**MHI's Response to NRC's Follow-Up Request
for Additional Information**

**Mass and Energy Release Analysis Code Applicability
for US-APWR Topical Report MUAP-07012-P**

February 2008
(Non-Proprietary)

Figure 1 Containment Pressure

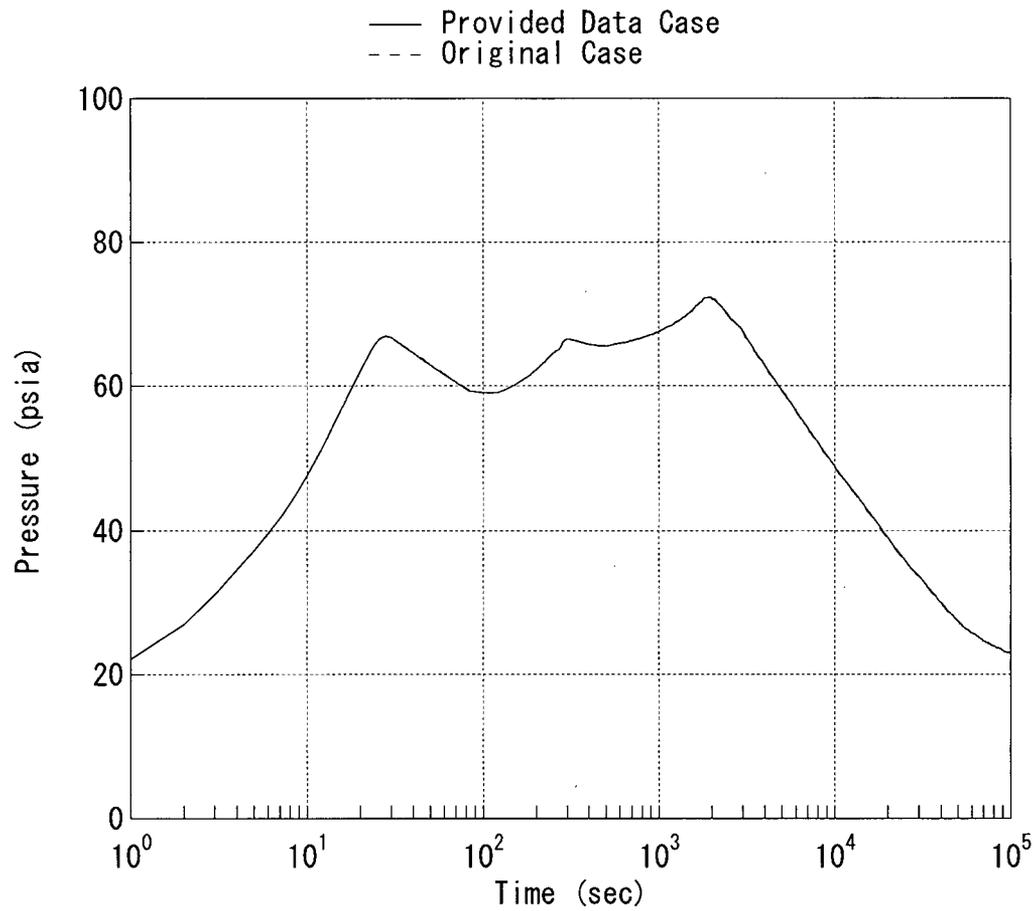
"Please provide the NRC staff with an electronic file of the US-APWR GOTHIC input for the double ended pump suction break. The staff would like to use this input to develop a description of the US-APWR containment using the MELCOR computer code for the purpose of performing confirmatory analysis. We also would like to share it with NRC research staff as they are developing a MELCOR containment model for the Chapter 6.2 evaluation."

This report documents MHI's response to the following NRC's RAI dated January 30 2008 concerning the topical report, MUAP-07012-P(R0), "LOCA Mass and Energy Release Analysis Code Applicability Report for US-APWR".
